Town of Parker Community Development Department
 Development Review Division
 Attention: **Ashley Chasez**

Application Type: **Site Plan**
 Status: **First Referral**
 Application Name: **Parker Point F1 L10 Medical Office Building**
 Case/AP#: **SP23-058**
 Referral Received: August 11, 2023
 Comments Due: September 1, 2023

Review date: **August 11, 2023**
 Plan reviewer: **Randall L. Capra, rcapra@parkeronline.org**
 Phone: 303.805.3163

TOWN OF PARKER - FIRE/LIFE SAFETY:	C REVIEWED FOR CODE COMPLIANCE w/COMMENTS
---	--

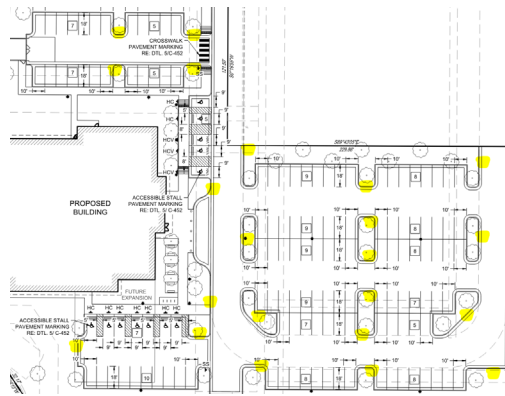
4. The location of the required fire department connection (FDC) shall be in the area of the riser room and required fire hydrant (not isolated from the riser room as currently shown). The applicant shall provide a minimum 5-foot sidewalk from the emergency access lane to the riser room. Address this issue when resubmitting. *Satisfied with the second submittal; applicant has noted compliance with this requirement.*

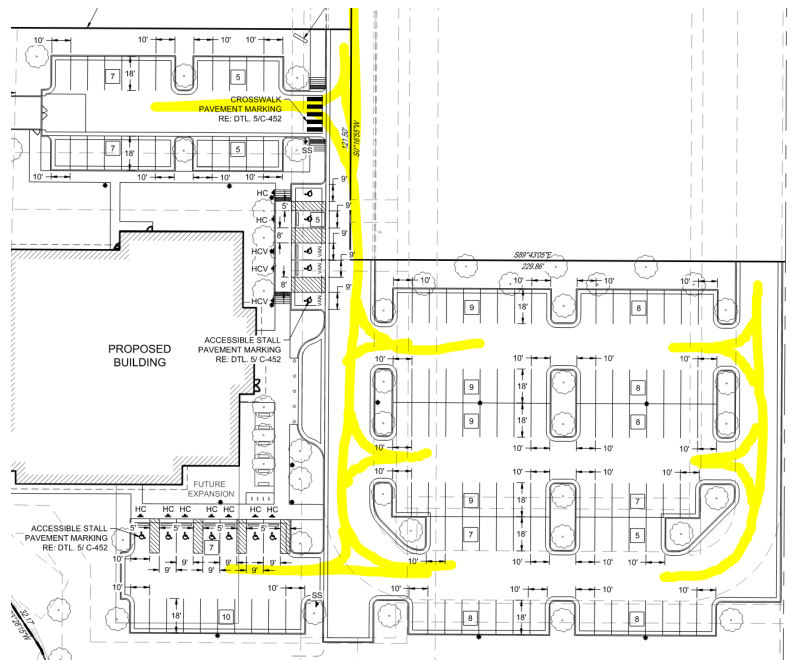
- 14. While the applicant has not provided an auto turn analysis indicating that apparatus can navigate all portions of this site, an auto turn analysis will be required addressing the areas shown below (in yellow) when resubmitting: *Satisfied with the second submittal; applicant has noted compliance with this requirement.*
